**HARTZELL PROPELLER INC.**  
**ALERT SERVICE BULLETIN**  
**TRANSMITTAL SHEET**  
**HC-ASB-61-333**  
**Propeller - Blade Replacement -**  
**Aero Twin STC SA02291AK**

March 6, 2013

This page transmits a revision to Alert Service Bulletin HC-ASB-61-333.

- Modify the compliance criteria
- Modify the length of the warranty
- Change reference to STC SA02291AK in Accomplishment Instructions

**Blade Butt Showing Damage to Prevent Further Use of the Blade**  
**Figure 1**

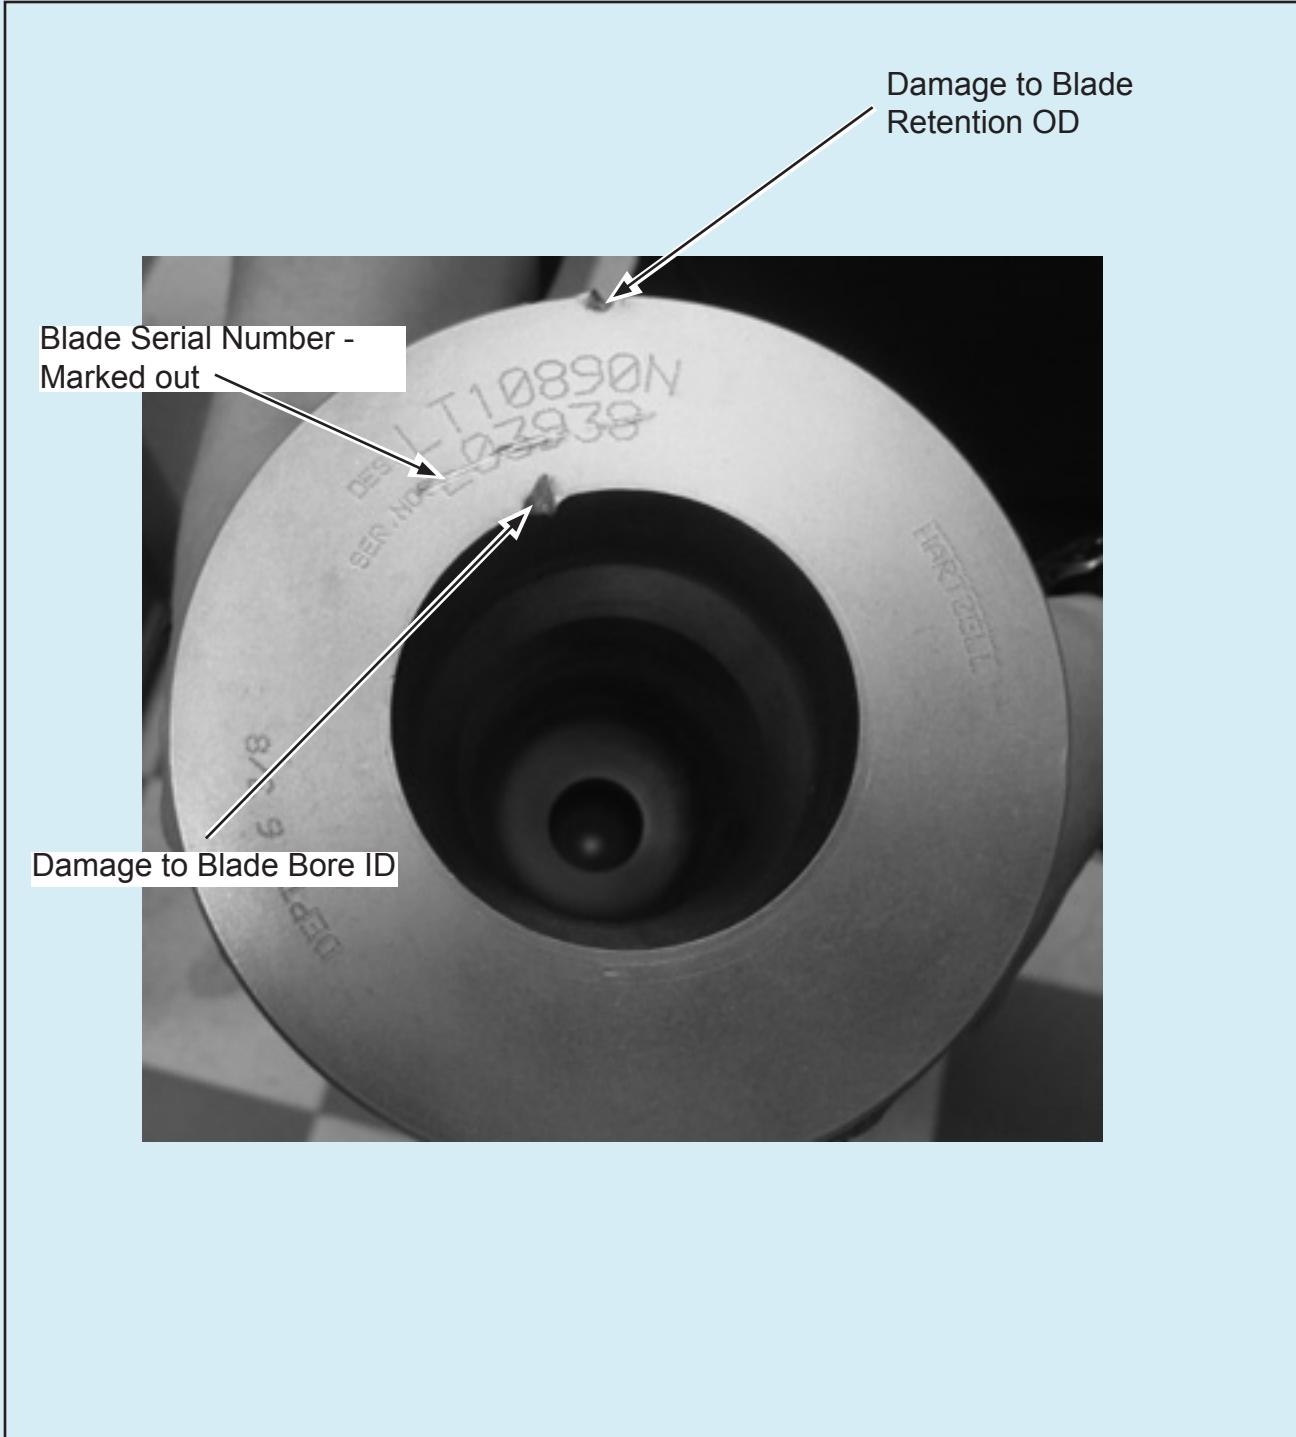
- 1 Using a tool, damage the ID of the blade bore and the OD of the blade retention surface. Damage must be sufficient to prevent installation of the blade bearing or the blade clamp. Refer to Figure 1.
